TECHNICAL MEMORANDUM

TO: Mr. Peter Delaney, Chair Town of Boxford Conservation Commission
FROM: Bree D. Sullivan, P.E.
DATE: August 8, 2019
RE: **NOI# 114-1283 - Lockwood Lane Bridge Replacement**

This memorandum has been prepared to provide additional information requested in a August 8, 2019 email from Ross Povenmire, director of conservation.

DEWATERING SETTLING BASIN DETAIL
NOT TO SCALE

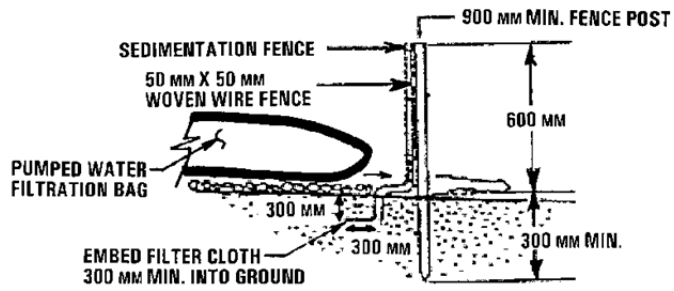
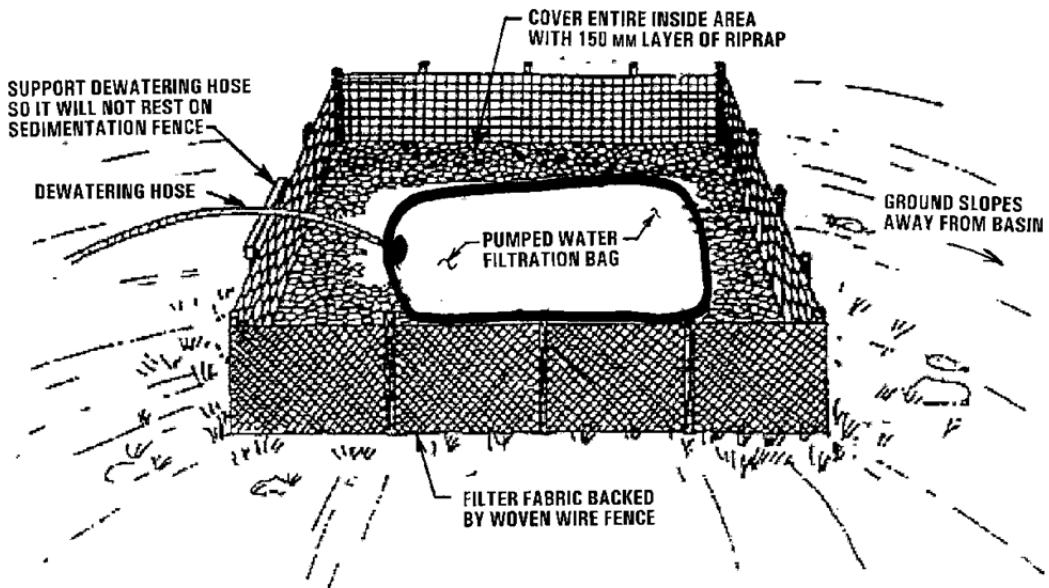
Q: The proposed plan does not provide details on dewatering of the work area, and instead refers to a plan for “channeling water, bypass pumping or blocking streamflow” to be provided by the contractor to the engineer. I anticipate the ConsCom will want to understand the dewatering process prior to issuing an Order of Conditions, and suggest that the project plans be more specific with regard to this crucial step.

A: Control of water procedures will be determined by the contractor based on their experience and their field investigation. The plans are clear about construction occurring “in the dry” and in a manner that minimizes sediment deposition in the stream. The contractor is required to develop and submit a complete control of water and dewatering plan prior to commencement. The possible different types that can be used are driven sheet cofferdams, portable temporary dam structure(s), and channelization structures. The project will likely be constructed in stages – excavation and construction of the westerly abutment behind the existing abutment (in part), then disassembly of the existing abutments and excavation and construction of the easterly abutment. Dewatering will include pumping to a filtration bag. The filtration bag detail and approximate location is shown on sheets E-6 and E-5, respectively. Optionally, the commission could require submittal of the approved control of water plan as part of the Order of Conditions. See attached selected Special Provisions for additional detail.
